## Meeting note

<b>Project reference</b>	EN070001 – Yorkshire and Humber CCS Cross Country Pipeline
<b>Status</b>	Final
<b>Author</b>	Hannah Pratt
<b>Date</b>	13 June 2014
<b>Meeting with</b>	National Grid and Natural England
<b>Venue</b>	Teleconference
<b>Attendees</b>	<p><b>Applicant</b> Richard Gwilliam (National Grid) John Hartley (Hartley Anderson Limited) Nigel Pilkington (Aecom) Charlotte Clinton (Aecom)</p> <p><b>Natural England</b> Deborah Hall James Bussell Emma Brown James Walsh</p> <p><b>Planning Inspectorate</b> Tom Carpen (Infrastructure Planning Lead) Iwan Davies (Case Lead) David Price (EIA Manager) Hannah Pratt (EIA and Land Rights Advisor) Richard Kent (EIA and Land Rights Advisor)</p>
<b>Meeting Objectives</b>	To discuss the Habitats Regulations Assessment (HRA)
<b>Circulation</b>	Meeting attendees

## **Yorkshire and Humber CCS Cross Country Pipeline: No Significant Effects Report and Statement of Combined Effects**

### **Yorkshire and Humber CCS Cross-Country Pipeline – No Significant Effects Report (NSER)**

**Figure 1: Storage area location, indicative offshore pipeline route and landfall**

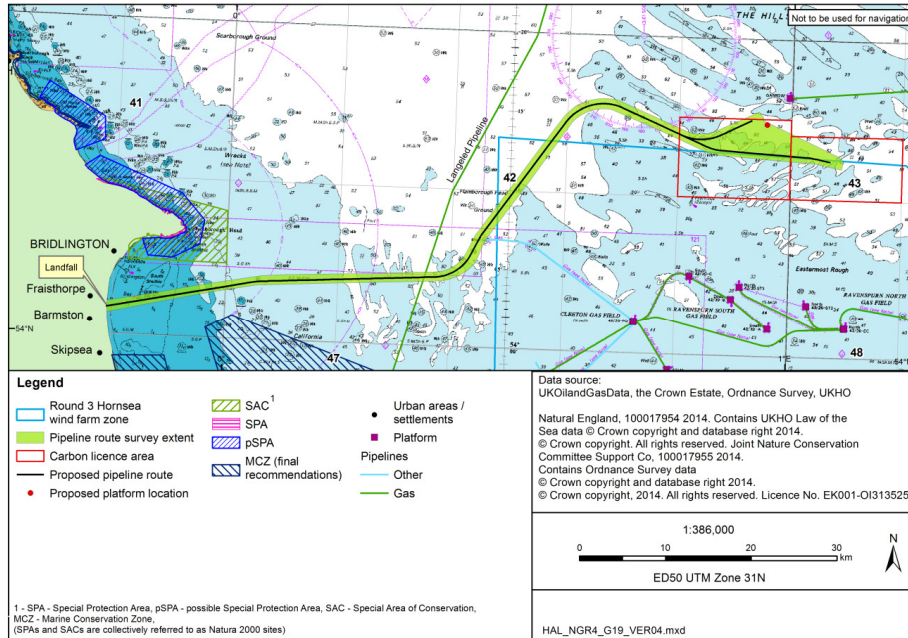
We acknowledge that information has been provided on the marine pipeline construction in sections 5.2.9 and 5.2.10 of the Statement of Combined Effects. However, we advise that further detail is provided in order to determine whether there will be significant changes to sediment transport which could impact on the Humber Estuary SAC / SPA. This should include the following:

- The depth of offshore pipeline burial, and the method of storage of backfill material from the nearshore excavation trench.
- The degree of seabed scour that will result from pipeline construction.
- The quantity and type of material used for any rock placement, concrete or frond matting used to protect the pipeline from exposure and subsequent scour, and any effect this may have

- on water quality and therefore on the marine ecology of the Humber Estuary.
- The longevity of the pipeline, and any likely maintenance requirements for the pipeline and Normally Unmanned Installation which may affect sediment flow.

The Offshore Scheme comprises a Pipeline linking the landfall to a Normally Unmanned Installation (NUI) and related infrastructure (e.g. wells, platform power generation facilities etc.) and is illustrated on Figure 1 below:

The offshore Pipeline will comprise of approximately 90 km of up to 610 mm concrete coated carbon steel Pipeline and will be laid from the landfall to a NUI located at the geological storage site.

The proposal is for the pipeline to be buried in the nearshore out to the 30 m depth contour and subsequently surface laid to the offshore platform (NUI) at the storage site. A geophysical survey and subsequent geotechnical survey of the pipeline route indicate that there are no obstructions which would prevent such an approach to installation, and similar techniques have been employed for existing pipelines associated with the Easington gas terminal, such as York and Langeled.

**Figure 2 – Estimated total at sea use of grey seals**

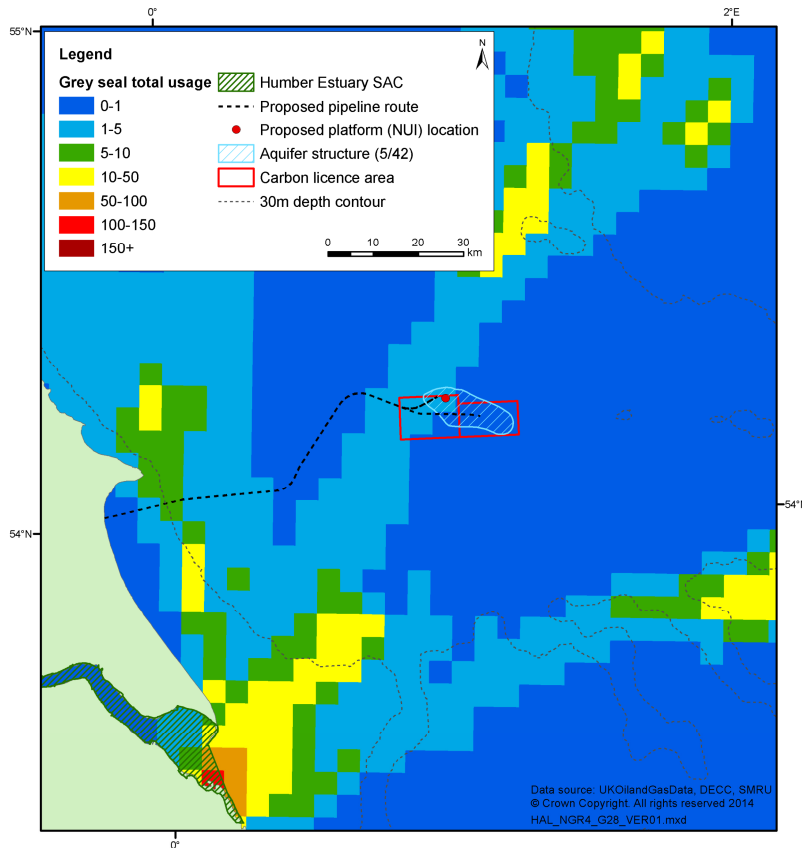
We note from the information in Table 4 of the SoCE that the offshore scheme has the potential to impact on seabirds which are interest features of Flamborough Head pSPA, and grey seals which are an interest feature of the Humber Estuary SAC. We advise that further information is provided on the following:

- Details and duration of installation activities such as vessel movements, and the distance of these activities from Flamborough Head pSPA.
- Details and duration of any activities (either during construction, operation or decommissioning) causing noise and vibration which may impact on grey seals. It should be noted that noise effects in combination may have a greater impact than the sum of individual effects.
- Water quality impacts as noted above.

The Humber SAC is approximately 50 km from the Offshore Scheme at its closest point. The nearest seal haul out site is Donna Nook on the entrance to the Humber Estuary (approximately 70 km to the south). A Grey seal usage map is presented in Figure 2 below which is derived based on seal tag telemetry data indicates limited usage of the Offshore Scheme area.

There is no mechanism for the Offshore Scheme to directly affect this interest feature within the Humber SAC, as it is located 50 km from the Offshore Scheme, the installation will be temporary, being limited to a 4 month period and there is limited usage of the Offshore Scheme area by this interest feature. Grey seal usage of the Offshore Scheme area is very low, with the majority of the 5km squares monitored showing number in the range of 0-1 and 1-5, compared to 10-50 and 50-100 individuals per 5km square closer to the estuary.
